Memo

Date: January 10, 2019

Re: **Review of Watercourse Constraint Ranking for Watercourse Reaches 'C-1' and 'C-2', Vision Georgetown Secondary Plan Area, Town of Halton Hills**

Figure 5.9.1

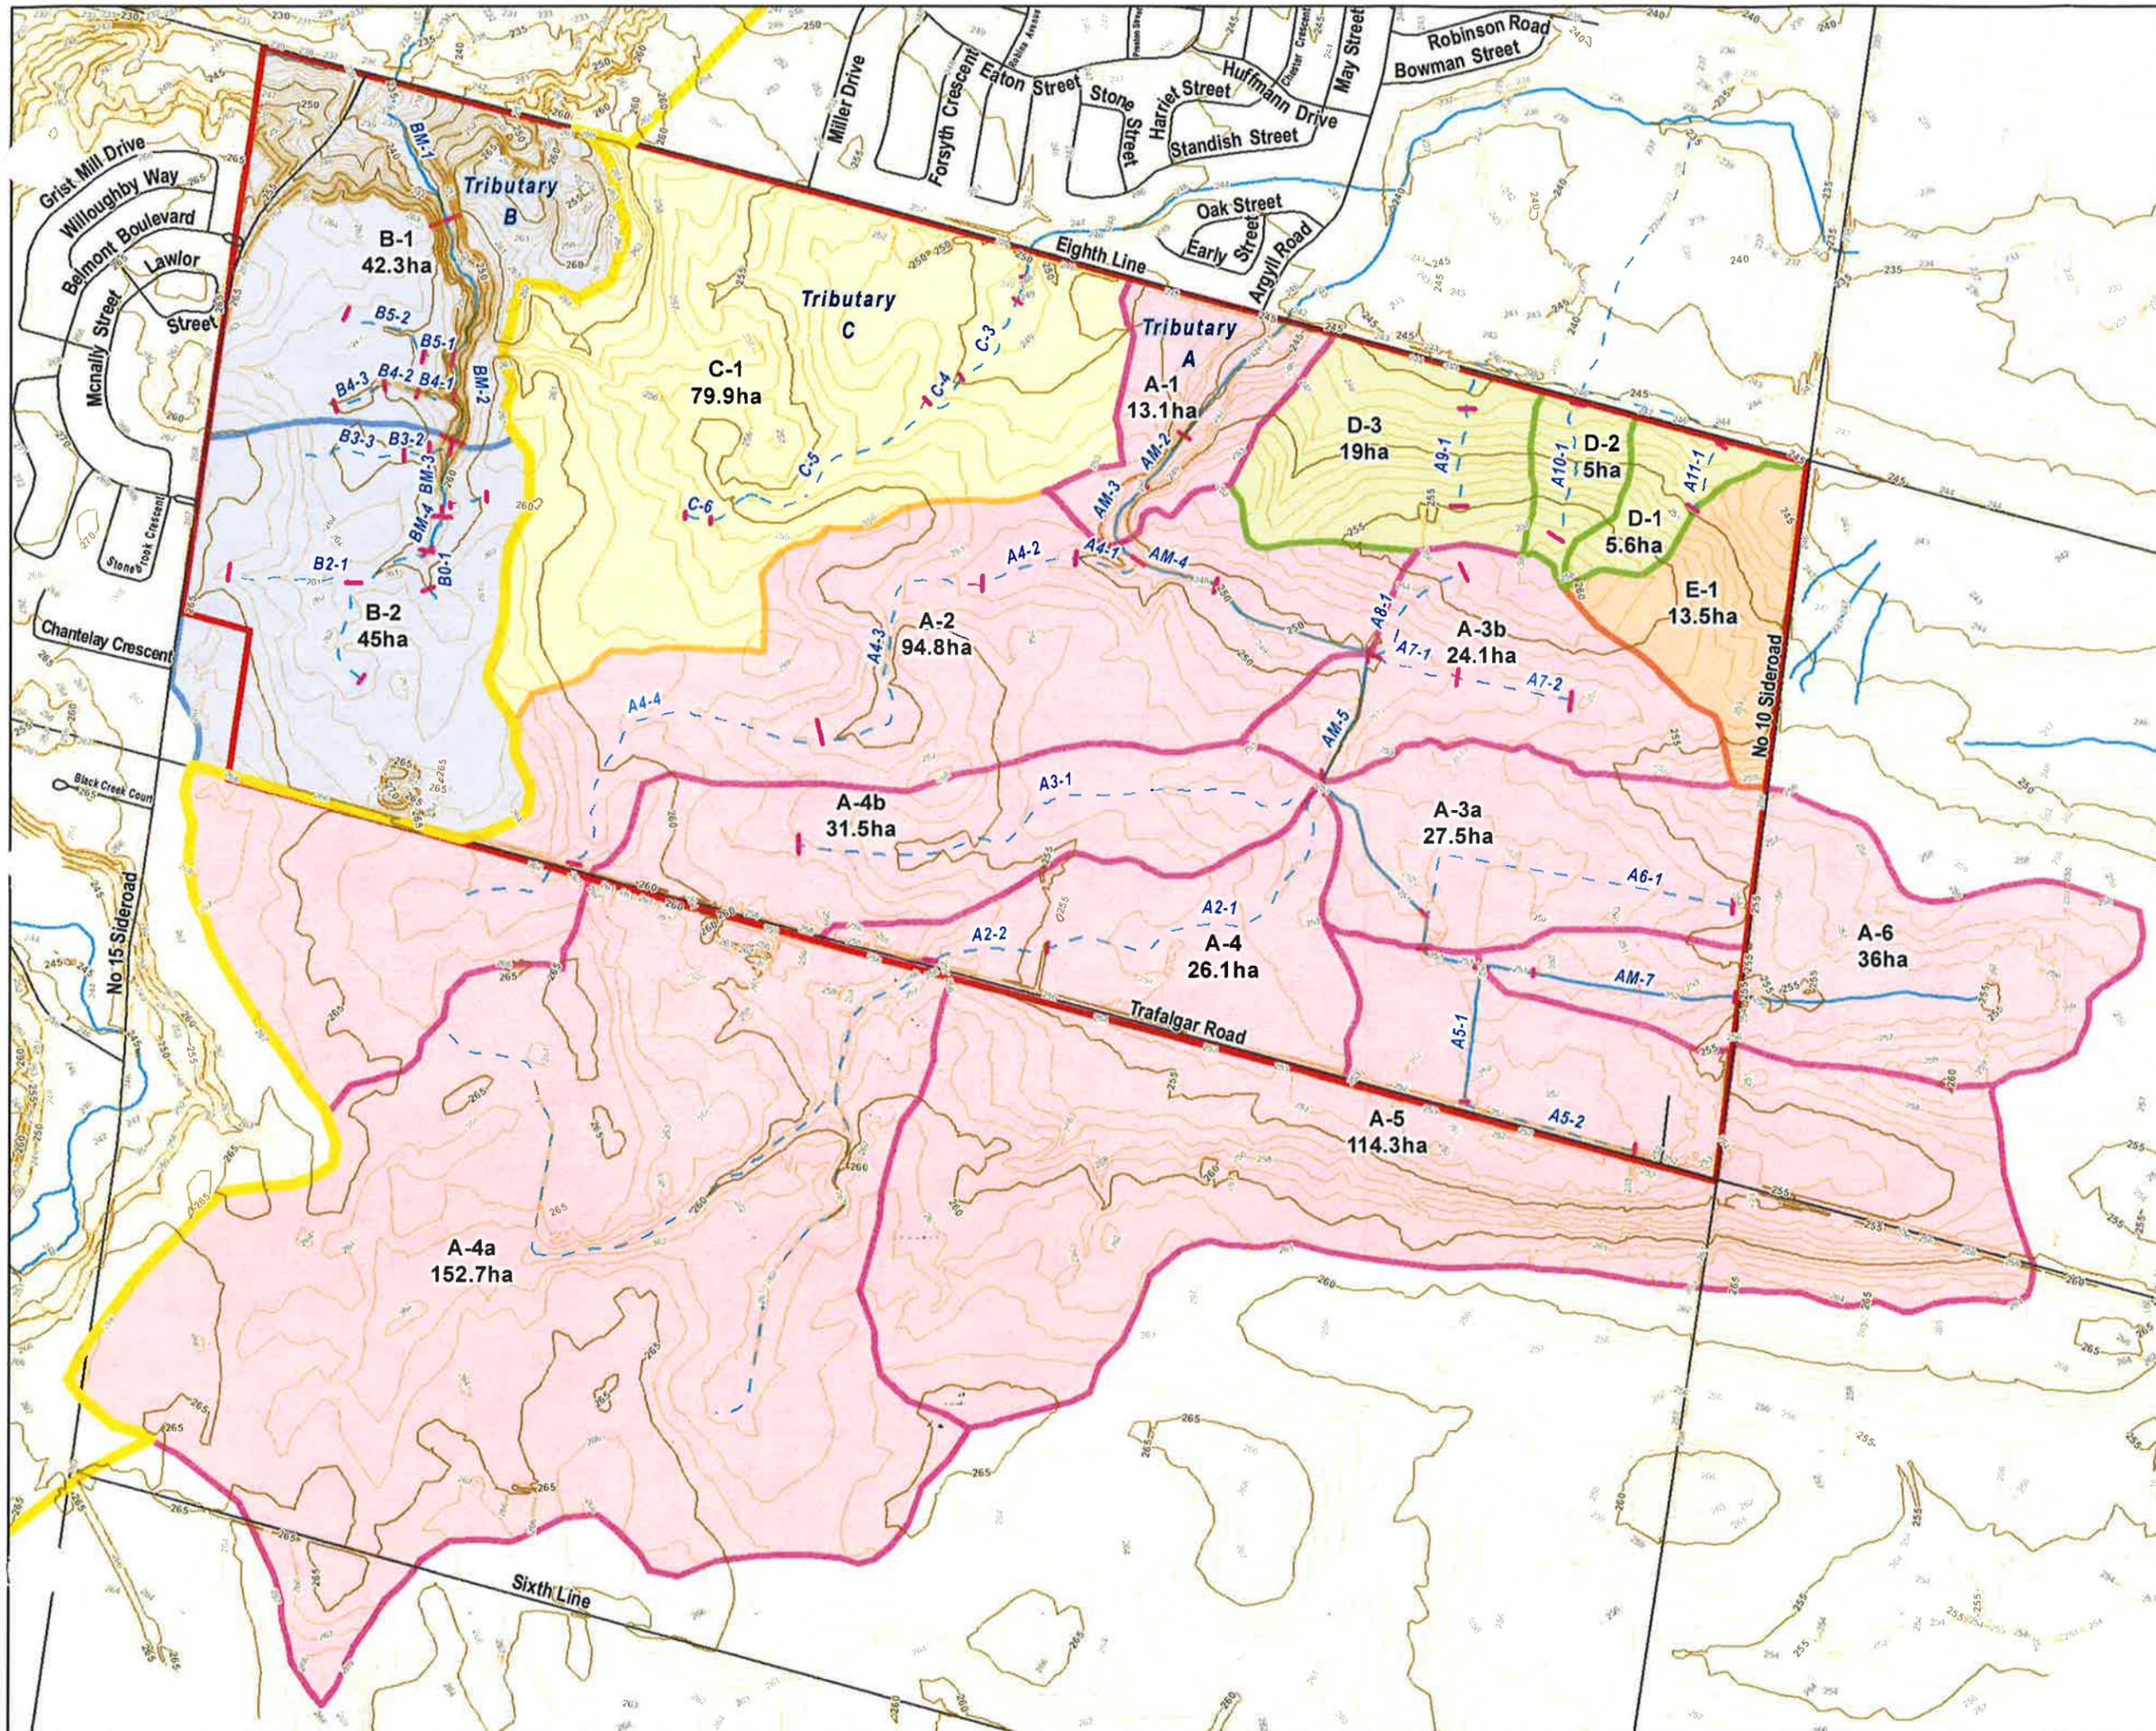
The subject watercourse reaches 'C1' and 'C2' are located toward the terminus of Tributary 'C', and immediately upstream of Eighth Line. Tributary 'C' is the second tributary in the study area that is within the Sixteen Mile Creek watershed, conveying flows across Eighth Line. It confluences with Tributary 'A' approximately 500m downstream of Eighth Line and then crosses Side Road 10. As part of the May 2017 Subwatershed Study, Tributary 'C' has been subdivided into six (6) stream reaches for the watercourse constraint ranking (ref. Figure 5.9.1 attached).

The information provided within the May 2017 Subwatershed Study indicates that the contributing drainage area to reach 'C1' measures 70.6 ha at the downstream limit at Eighth Line. A review of the contour mapping provided within the Subwatershed Study indicates that the size of the contributing drainage area is due to the confluence of the downstream limit of the watercourse with roadside ditches west of Eight Line. Immediately upstream of this confluence, the contributing drainage area would be reduced to 56.1 ha at the upstream limit of watercourse reach 'C1'.

The contributing drainage area to the upstream limit of reach 'C2' is 40.7 ha as specified in the May 2017 Subwatershed Study. The contributing drainage area to the upstream limit of reach 'C2' is noted to be less than the 50 ha limit generally applied as the threshold between "Low" and "Medium" constraint watercourses.

The information provided within the May 2017 Subwatershed Study indicates that contributing drainage areas to watercourse reaches 'C1' and 'C2' would be at or near the 50 ha threshold generally applied by Conservation Halton to establish regulated features based upon flooding hazard. As such, based upon the criteria presented in the Subwatershed Study and conventional practice, the contributing drainage areas to the watercourse features would be sufficient to classify watercourse reaches 'C1' and 'C2' as "Medium" constraint for flooding and conveyance criteria.

However, recognizing that the features are located within a lawn that is frequently maintained (ref. AECOM 2017, Appendix I), watercourse reaches 'C1' and 'C2' are considered to be subject to frequent disturbance as part of the routine lawn maintenance by the property owner. Furthermore, the 100m total reach length of watercourse reaches 'C1' and 'C2' are noted to be relatively small and further represent a low portion of Tributary 'C' which has been classified as a "Low" constraint watercourse, hence is considered to provide limited benefit to the flooding and conveyance system of the Vision Georgetown Area and the contributing drainage areas to the reach. In this regard, it is noteworthy that a similar situation was identified during the watercourse

Given the relatively small drainage area to the watercourse reaches, the frequent disruption of the feature due to lawn maintenance of the property, and the limited benefit derived from protecting the reach as an open feature for flooding and conveyance, we concur with the "Low" constraint ranking for the surface water component of watercourse reaches 'C1' and 'C2', as advanced in the May 2017 Subwatershed Study for the Vision Georgetown Area.
